The Glitch & The Fix, May 2015

End of the line?

The Glitch

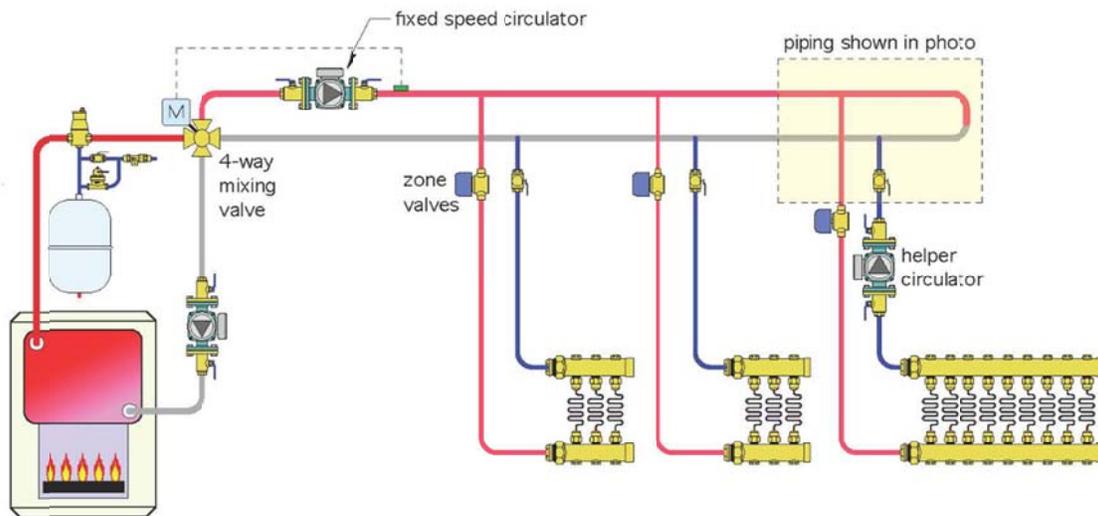
The piping in the photo shows part of the Glitch schematic. The piping to and from the two tees leads to a manifold station for radiant panel heating. One pipe is supply, the other is return. There is a “helper” circulator farther down the wall. The piping strapped to the bottom of the floor joists is supposedly part of a primary loop. The system is supplied by a low flow-resistance, cast-iron boiler. Water temperature is controlled by a motorized four-way mixing valve.

Examine the photo and the schematic, and list several things that need to be corrected.

The problem that will develop here is flow.

Think of it this way. If you were water being moved along the primary loop by the primary circulator and you could decide if you would rather go through those long radiant panel circuits, as well as the piping to and from the manifold station, or simply zip around the end of the loop seen at the right side of the photo, which would you choose?

If you said you would rather take the short loop around the end, congratulations — you're thinking like water!

Most (but not all) of the flow entering the tee just above the ball valve is just going to short-circuit around the end of this loop.

The Fix

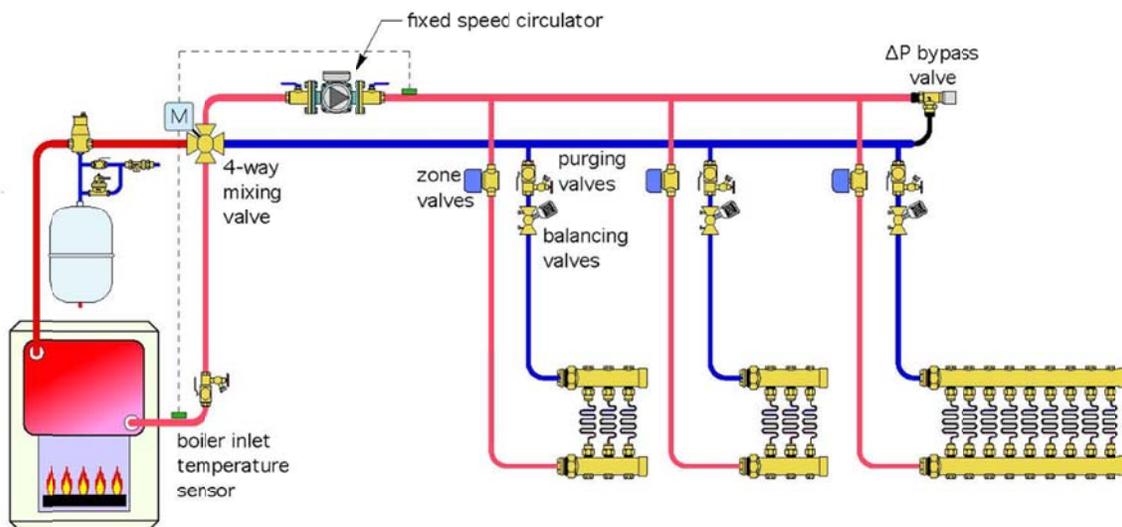
Although the installer probably thought he had created a primary loop, and even though those two tees are relatively close to each other, the take-off for the manifold station is not a secondary circuit. Neither are the other two circuits that serve the smaller manifolds. If the tees aren't right next to each other in the same pipe, it's not a secondary circuit.

When the far right circuit with the helper pump is operating, there is likely to be some flow reversal through the closed end of the primary loop. When water gets pushed out the end of a circulator, all it cares about is getting back to the other end of that circulator.

The shortest path for this is around the closed end of the piping loop at the far right of the schematic and photo. This will cause unintentional mixing. It also will affect the differential pressure driving flow through the other two manifold stations. The pressure drop around the closed end of the loop is likely to be quite low and, thus, there may not be sufficient differential pressure to drive adequate flow through the other two manifold stations.

Other details that are missing or unnecessary include:

1. Boiler inlet water temperature sensor to the mixing valve controller, which helps prevent sustained flue gas condensation.
2. Purging valves on the return side of each manifold station circuit.
3. If the four-way mixing valve is close to the low flow-resistance boiler, there is no need of a circulator between this valve and the boiler.

One way to fix the system is shown below.

This assumes a fixed-speed circulator to drive flow through the three manifold stations. Thus, a differential pressure bypass valve is shown at the end of the headers. It should be set about 0.5 psi above the differential pressure needed when all three zone valves are open under design load conditions.

Another option, which wasn't available when this system was installed, is a variable-speed, pressure-regulated circulator. If used, this circulator would eliminate the need of the differential pressure bypass valve. A savings that — today — would likely be greater than the additional cost of the variable-speed circulator.

Balancing valves have been added to each manifold subcircuit. These may not be necessary if the manifold stations have individual circuit-balancing valves.

A boiler inlet temperature sensor also has been added to ensure the boiler is not operating with sustained flue gas condensation.

If the system were installed today, three fixed-speed circulator could have been replaced by a single variable-speed, pressure-regulated circulator.
